HISTORIC AND DESIGN REVIEW COMMISSION

June 07, 2017

HDRC CASE NO: 2017-241
ADDRESS: 735 E GUENTHER ST
LEGAL DESCRIPTION: NCB 2882 BLK 7 LOT NE IRR 116.4 OF 8 & NE IRR 113.4 OF 9
ZONING: RM-4, HS
CITY COUNCIL DIST.: 1
DISTRICT: King William Historic District
LANDMARK: Wehrhan House
TYPE OF WORK: Construction of a rear carport
REQUEST:

4 CARPORT PLAN / PARTIAL SITE
A1 SC: 1/8" = 1'-0"

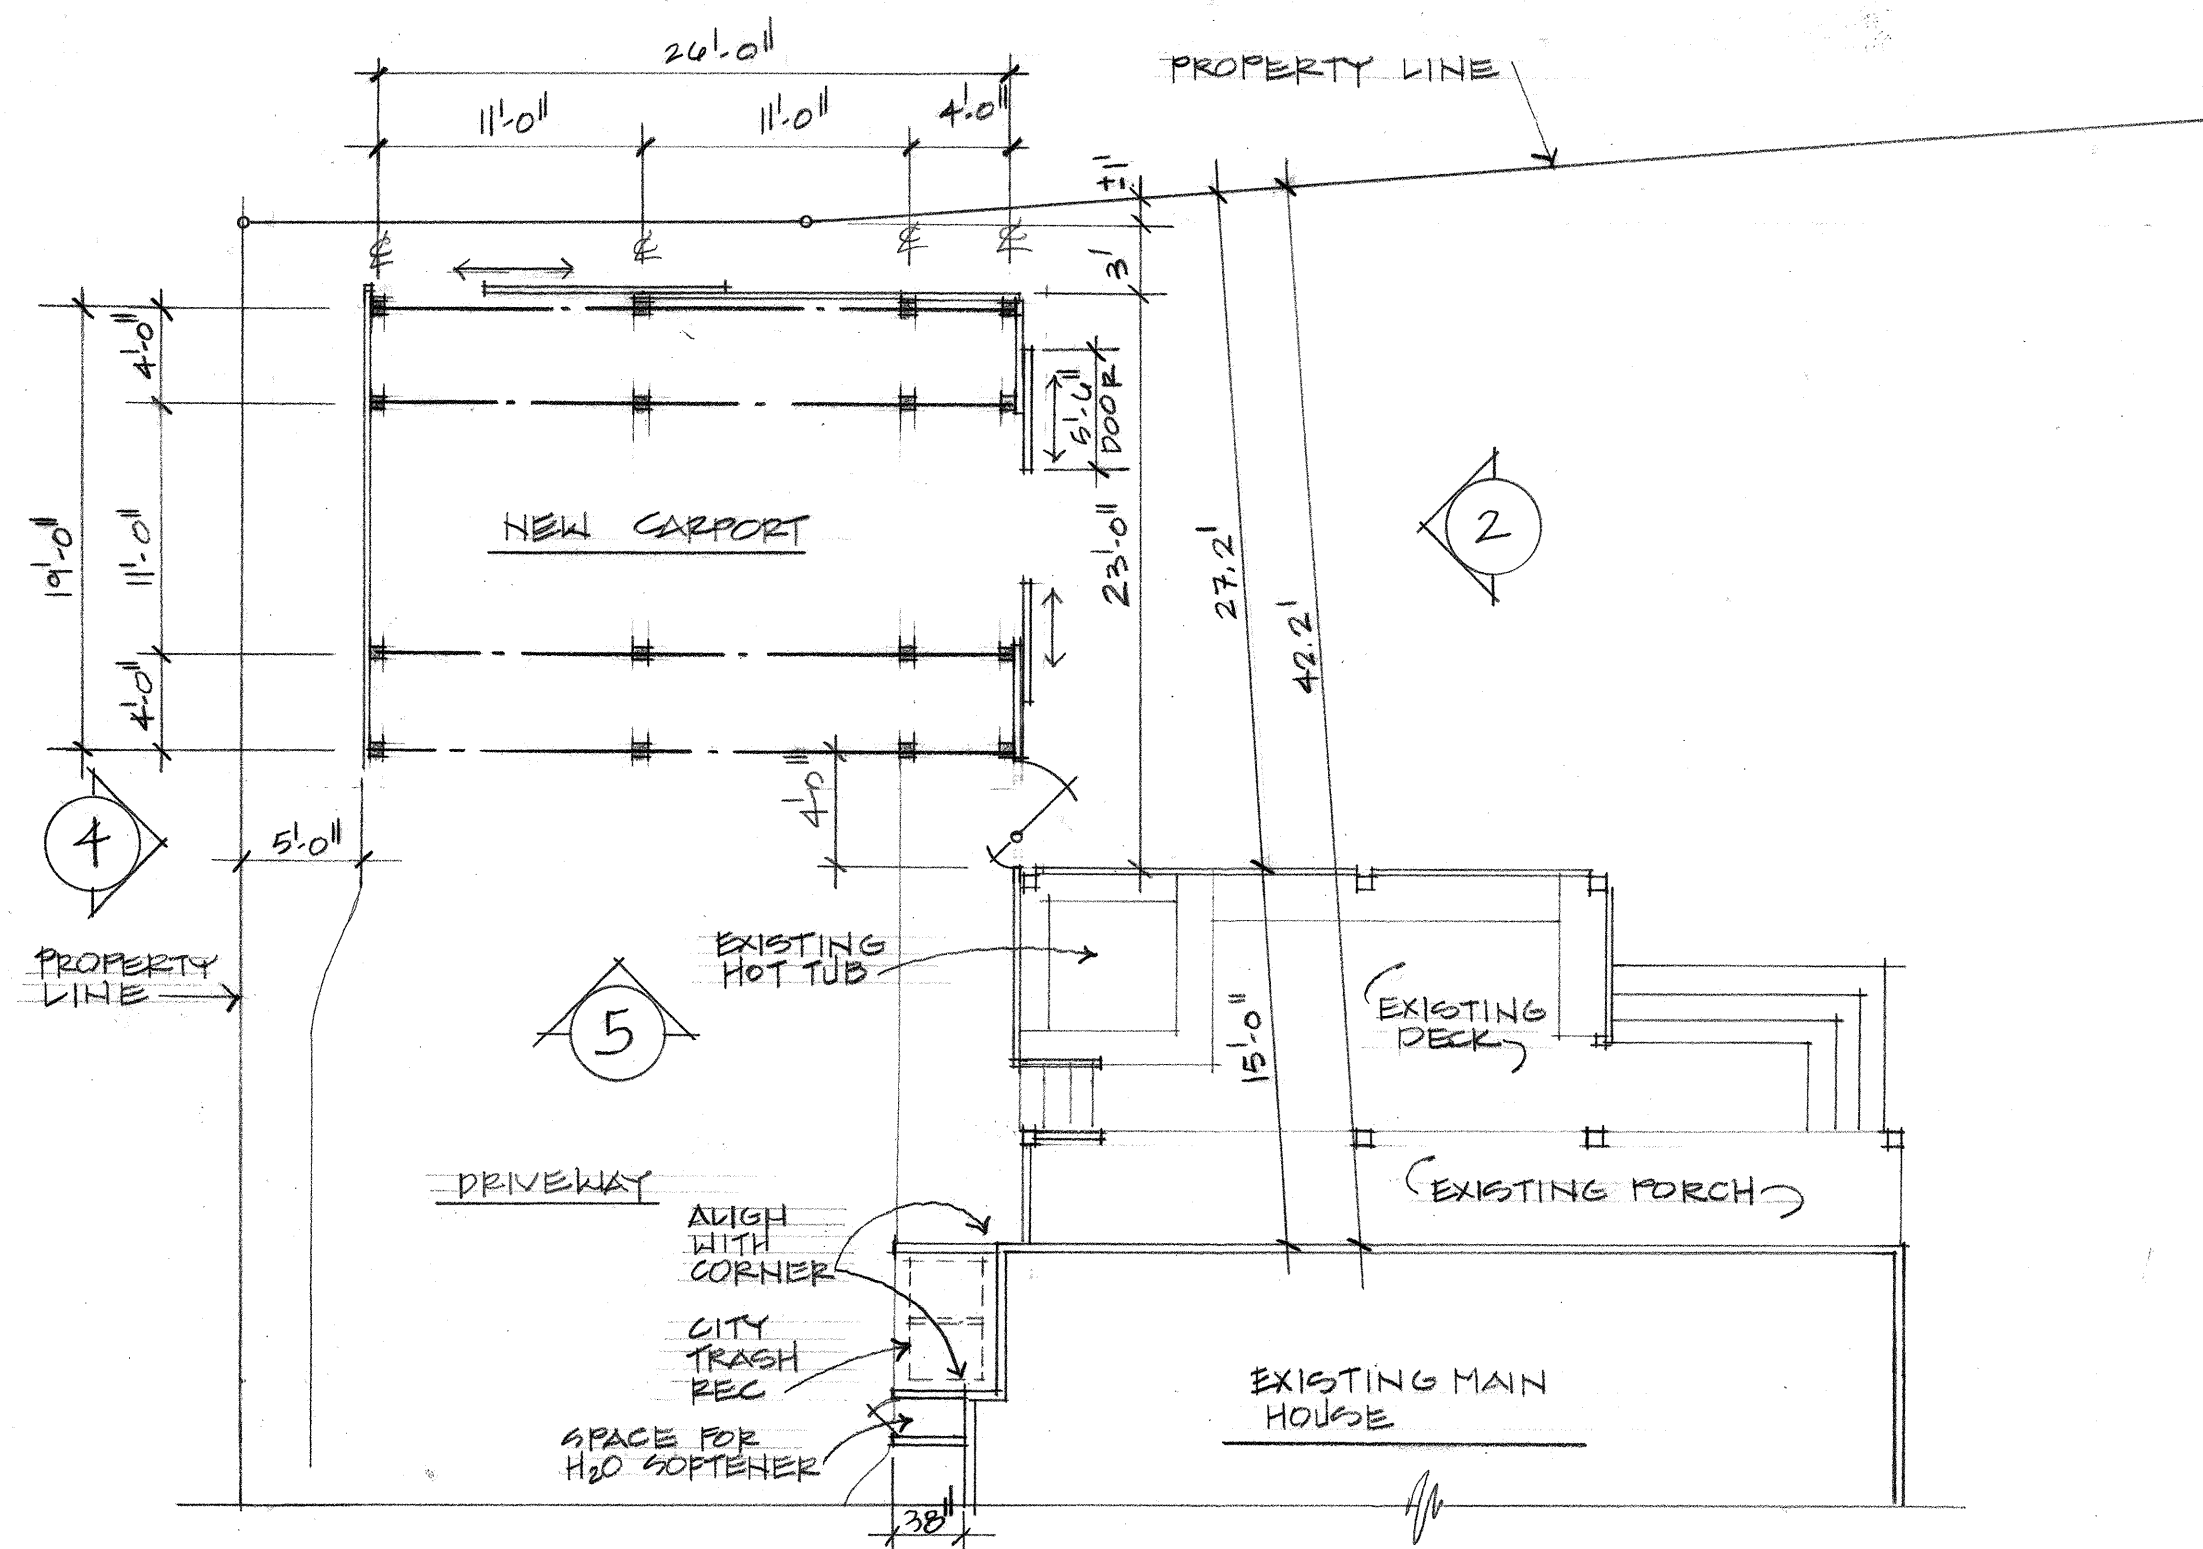
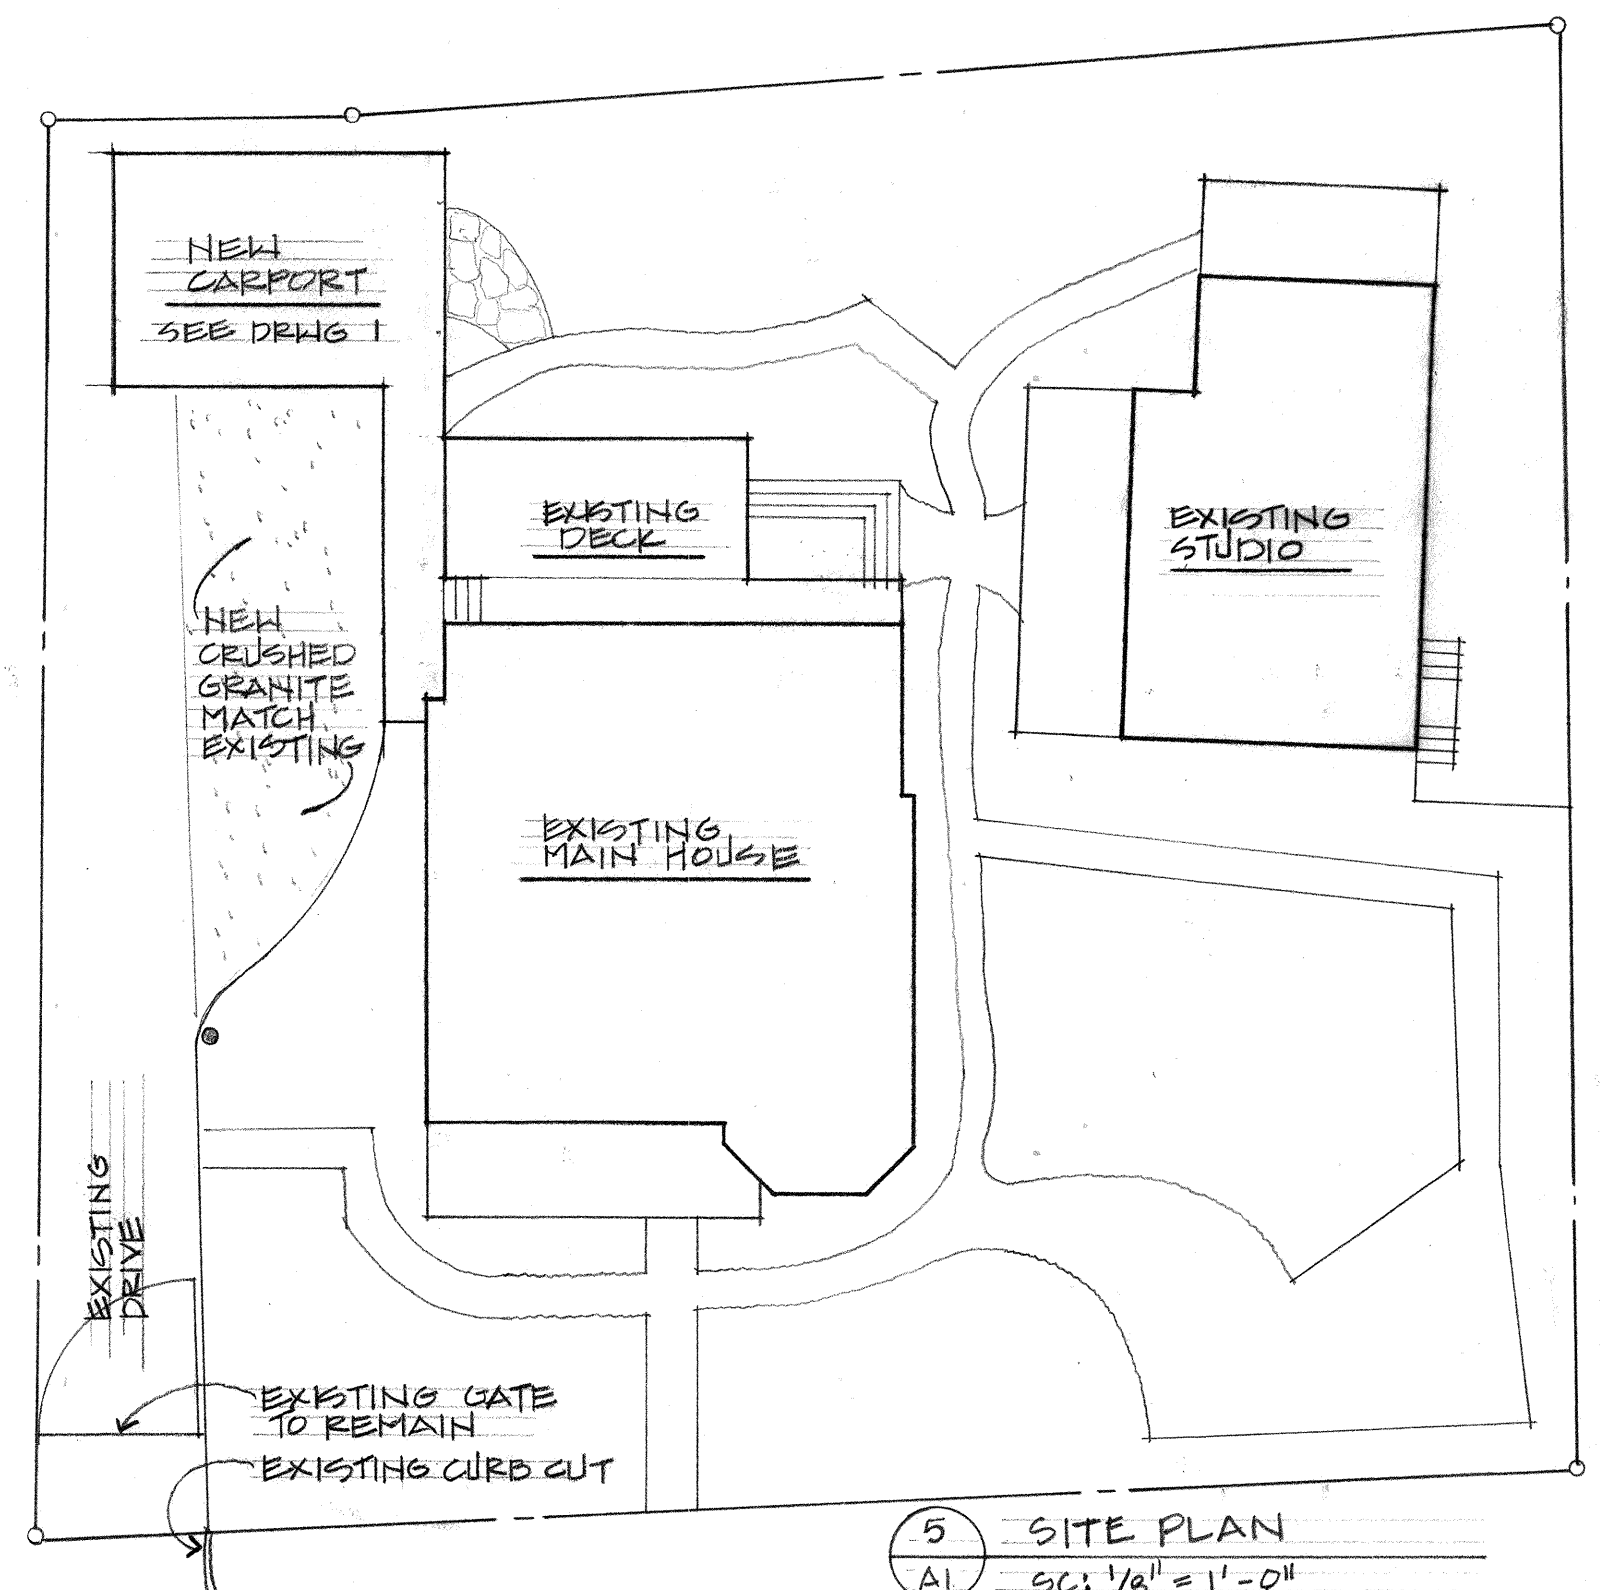
- d. **ORIENTATION & SETBACKS** – The applicant has proposed to site the carport in the southern corner of the site, typical to the location of historic accessory structures. This location is consistent with the Guidelines for New

- e. The proposed massing and location is typical for rear accessory structures throughout the King William Historic District and is consistent with the Guidelines.
